**FINAL LACTC STAFF COMMENTS
PASADENA-LOS ANGELES RAIL TRANSIT PROJECT
FINAL ENVIRONMENTAL IMPACT REPORT (FEIR)
STATE CLEARINGHOUSE NO. 89082327**

February 1990

PLAN AND PROFILE
HIGHLAND PARK ALTERNATIVE
STA 90+00 TO STA. 117+00

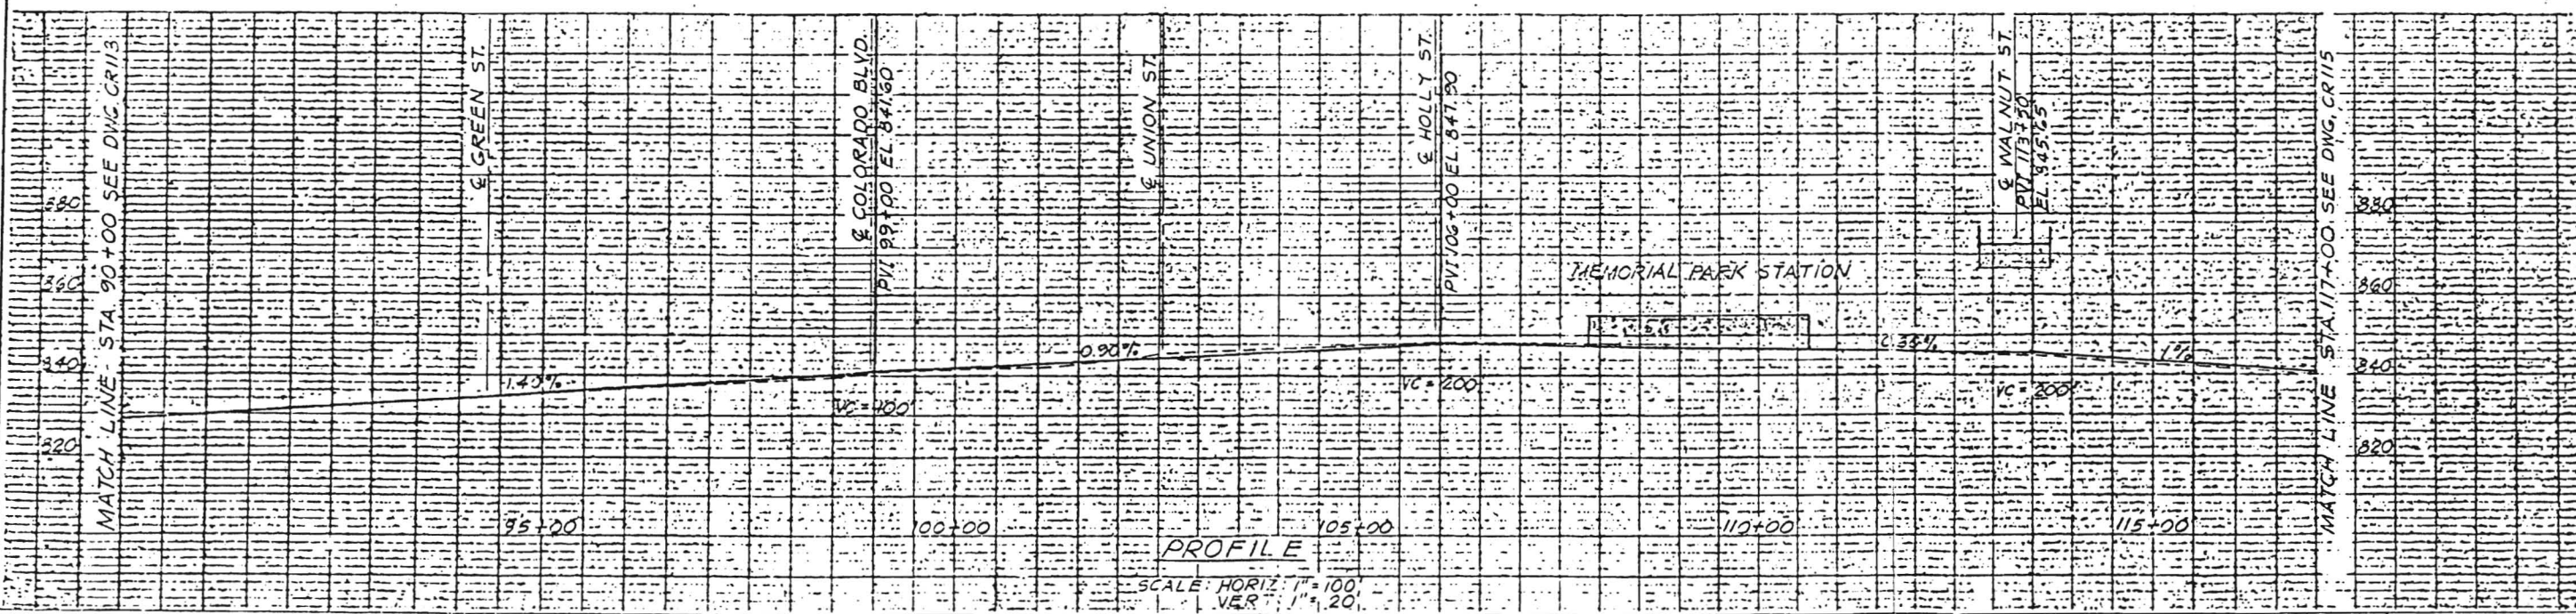
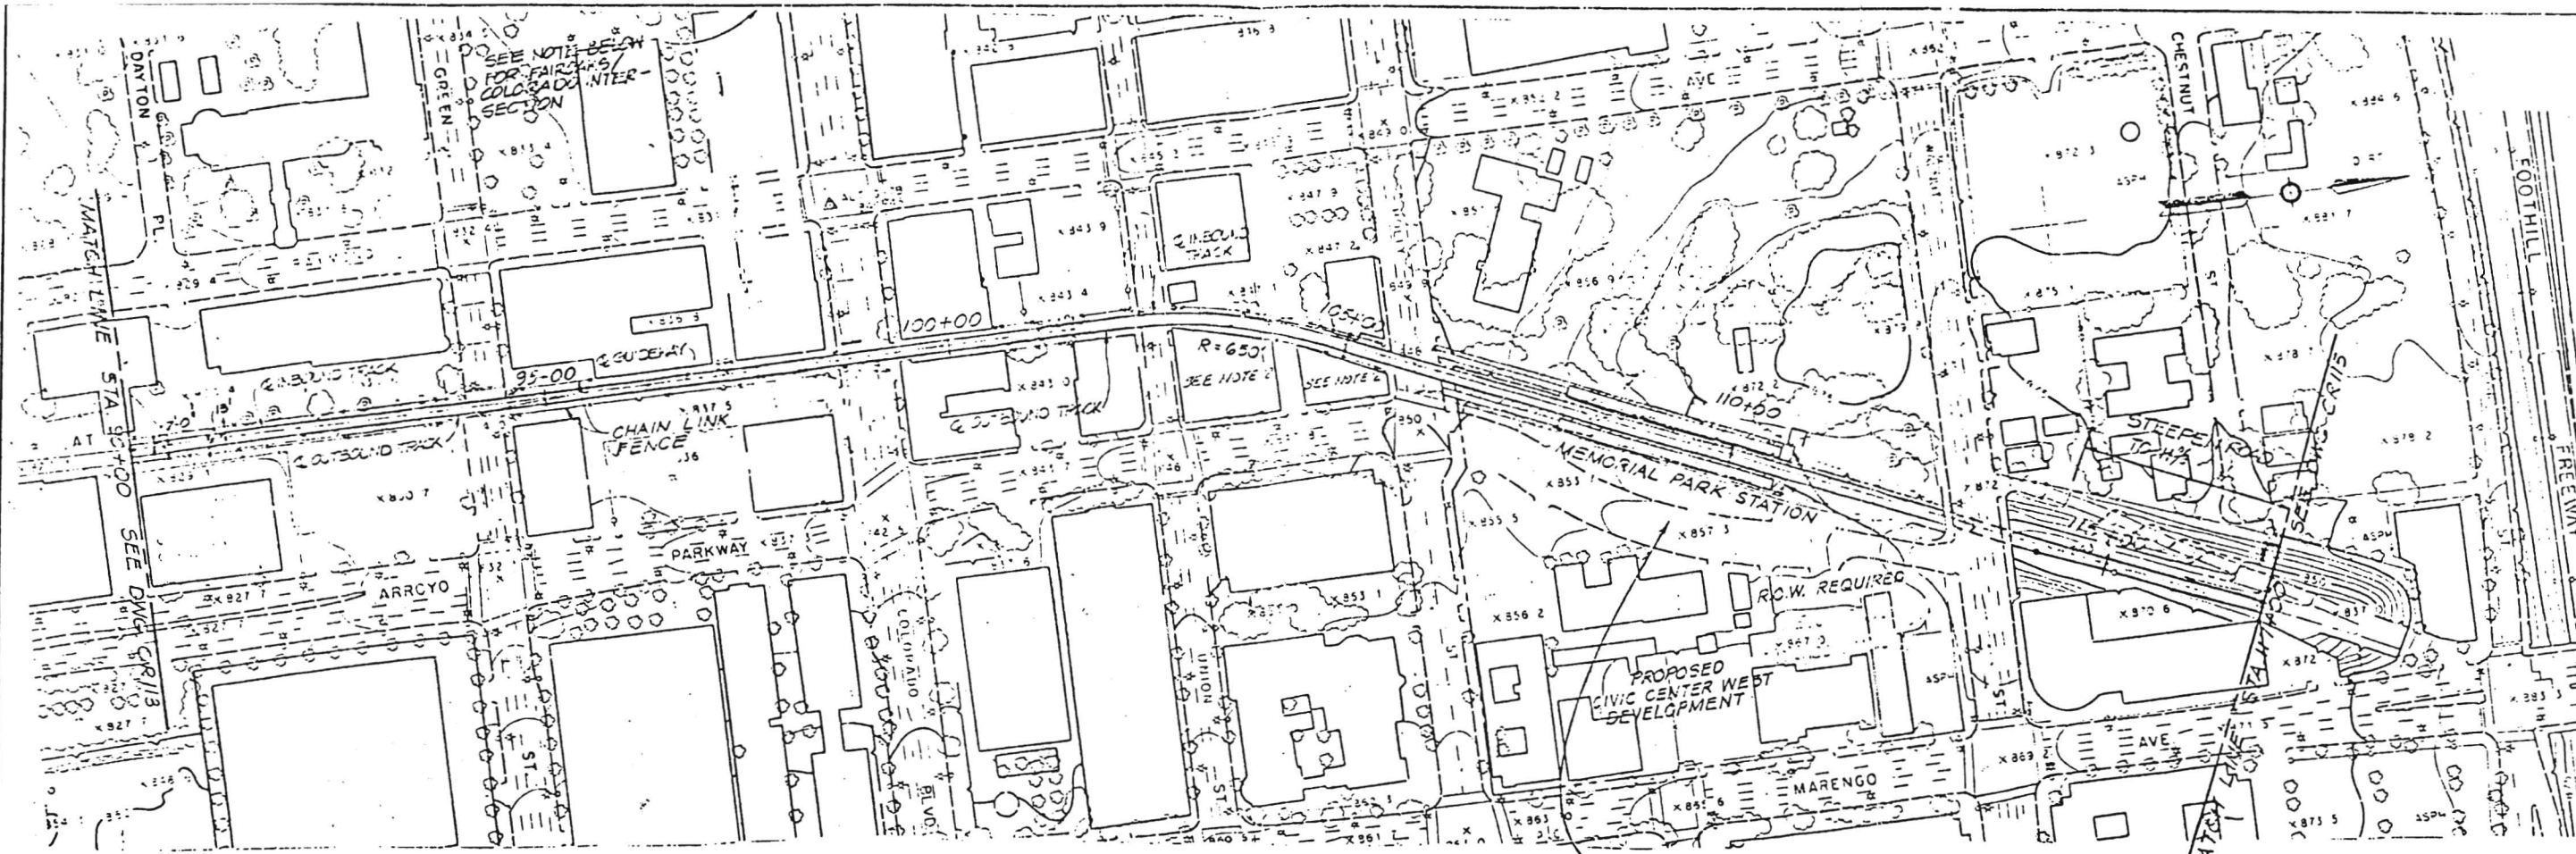
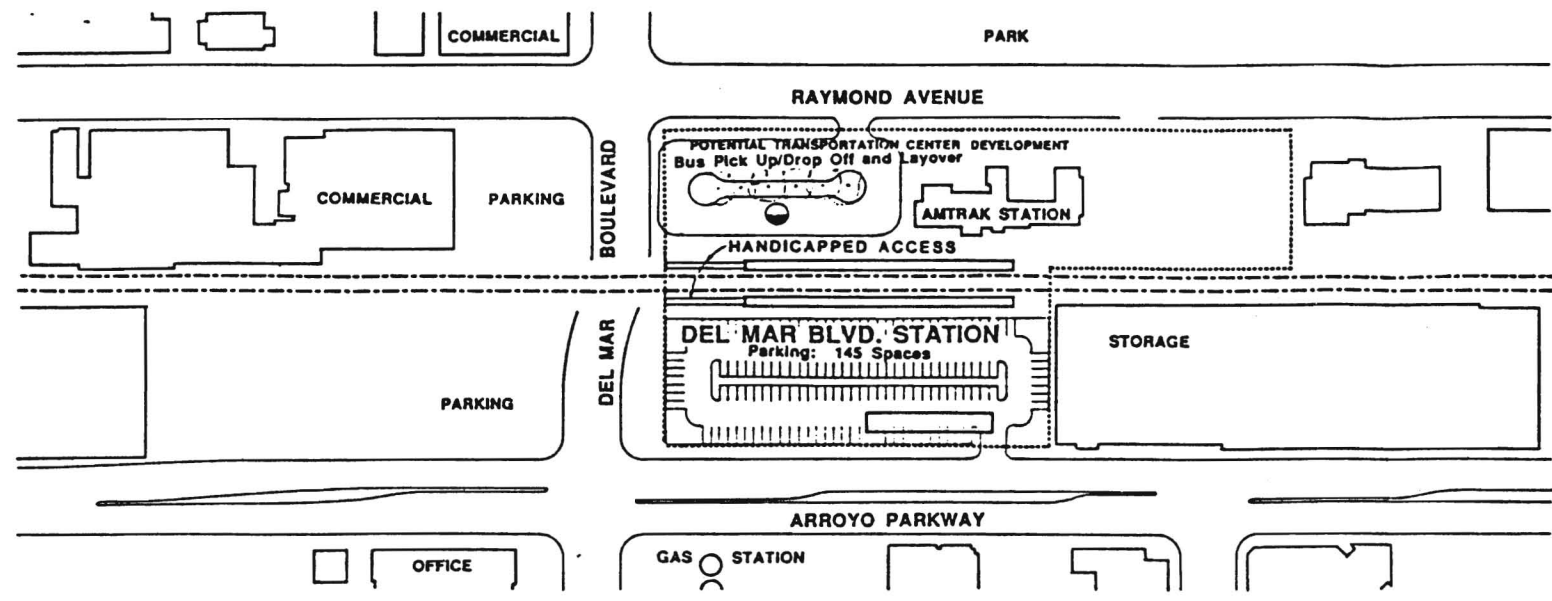
13. Mr. Richard Binder, general manager requested that the following text be inserted in the EIR that make specific reference to Phillipe's Original Restaurant:

References to the demolition of Phillipe's The Original restaurant should be inserted, at minimum, on pages 4-7, Table 4-1 "Displacement/Right-of-Way Impacts," Reference SC204/E; page 4-17, Table 4-3 "Sensitive Land Uses Adjacent ot Proposed Project," Chinatown option; and page 6-6, Table 6-1, "Preliminary Evaluation of Pasadena-L.A. Corridor Alternatives," North Main Street/Chinatown-Ord Route/Displacement Section."
